Re: Railway (Metrolink - Estuary to Charlemont via Dublin Airport) Order [2022]
Metrolink. Estuary through Swords, Dublin Airport, Ballymun, Glasnevin and City Centre to
Charlemont, Co. Dublin

RE: Railway (Metrolink-Estuary to Charlemount via Dublin Airport) Order 2022

We understand that the Bord will consider submissions in relation to the likely impacts of the proposed development. HSE have retained O'Connor Sutton Cronin & Associates Ltd (OCSC) to carry out an initial review of the MetroLink and its interfacing with our facility at 30/31 Pearse St.

Technical Note Re: MetroLink/HSE 30/31Pearse St.

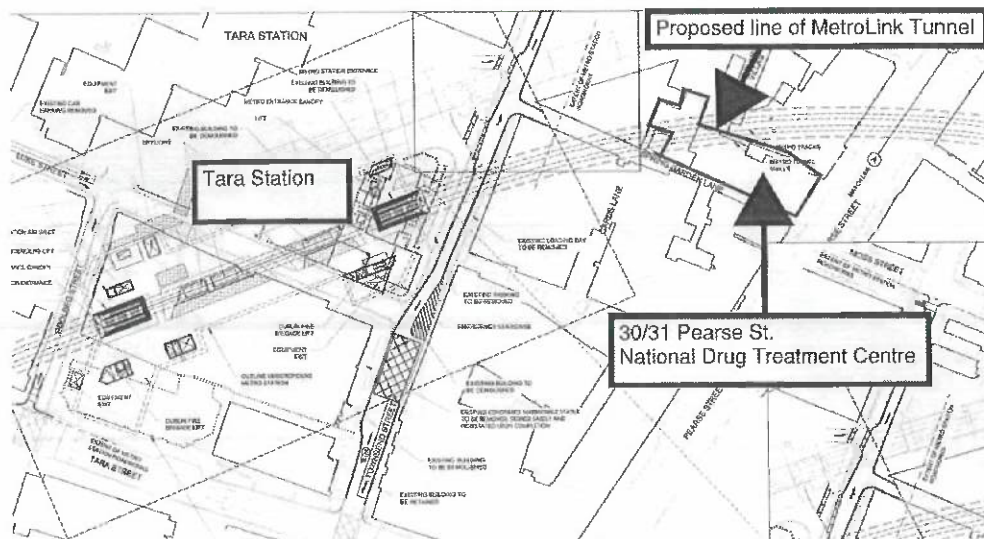
Reviewing the extract below from the proposed MetroLink Alignment drawings, it can be seen that the proposed alignment extends diagonally across the Northeast corner of 30/31 Pearse St, but most particularly under the new lift shaft enclosure as referenced earlier under 3.1 above. Tara Station is also in relatively close proximity to the rear of the building.

The depth of the tunnel where it passes underneath 30/31 Pearse St is approx:

- c.24m below existing ground/road to proposed track level
- c.15-16m below existing ground/road to crown of tunnel

4.2 Property Acquisition

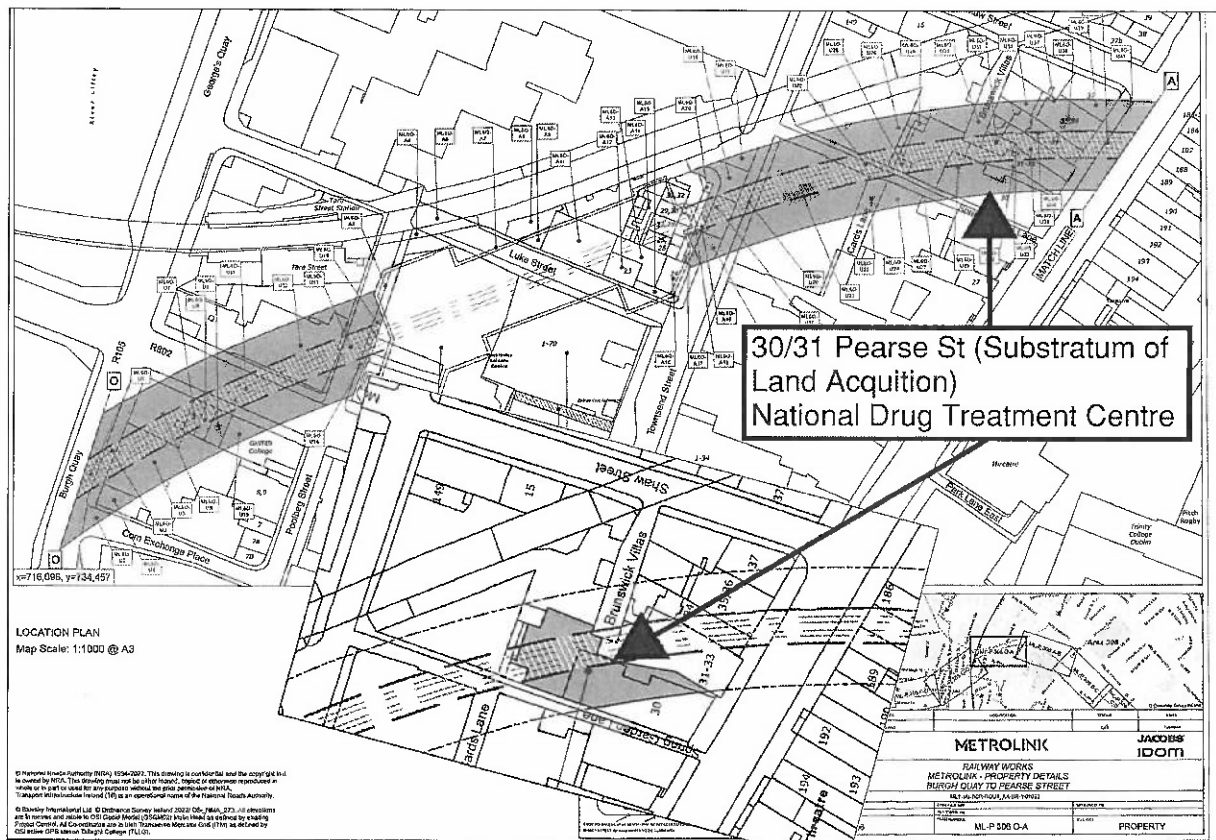
The Railway Order, if granted, will allow the Applicant, TII to proceed with the construction & operation of MetroLink. It also includes powers for TII to acquire compulsorily land or rights in, under and over land or any Substratum of land specified in the order. This will include Substratum lands at 30/31 Pearse St. and TII have forwarded the below relevant extracted drawings indicating the extent of the lands or rights affected as part of the Substratum acquisition relating to 30/31 Pearse St. with a unique land take reference number "**ML60-U29**". It can be seen that the substratum acquisition includes land both within and outside the building footprint.

Extract Fig 20.16 Settlement Contours (OCSC Mark-Up)

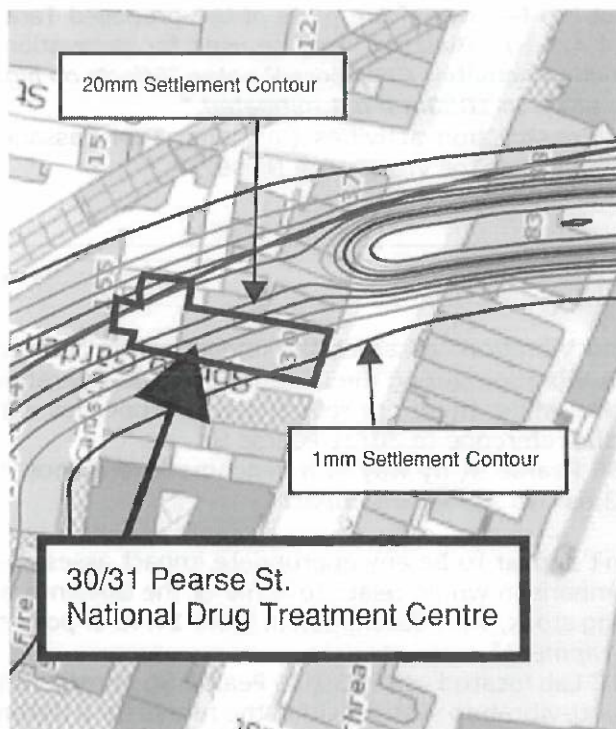
A marked-up extract (extract Fig 20.16 below) of the Phase 1 assessed "Greenfield" settlement contours relating to 30/31 Pearse St. is set-out below and from this assessment, it can be seen that the MetroLink has the potential to generate settlements of between 1mm to 20mm(plus) across the building footprint. More particularly, the assessment predicts a potential differential settlement varying between the 10mm-20mm contours across the area of the new liftshaft thus rendering vulnerable to out-of-plumbness. Such differential settlements have the potential to cause damage across the building and will thus necessitate the more detailed Phase 3 building damage impact assessment.

The Applicant does not appear to have given any specific consideration to 30/31 Pearse St. building which according to the Phase 1 "Greenfield" assessment seems to have the potential to cause damage which might affect the building, levels of service and its Occupants. As per section 4.1 of Appendix A5.17, 30/31 Pearse St. should be classified as a Type D "Sensitive" building with a Phase 3 damage assessment undertaken.

The Applicant should prepare a more detailed Phase 3 Building Subsidence & Damage Assessment specific for this building at 30/31 Pearse St, having specific regard for the more sensitive areas of the building.

The Applicant does not appear to have given any specific consideration to 30/31 Pearse St. building which according to the Phase 1 Generic Assessment Based on "Greenfield" Settlement Contours seems to have the potential to cause damage which might affect the building, levels of service and its Occupants. As per section 4.1 of Appendix A5.17, 30/31 Pearse St. shall be classified as a Type D "Sensitive" building with a more detailed Phase 3 Building Subsidence & Damage Assessment undertaken.
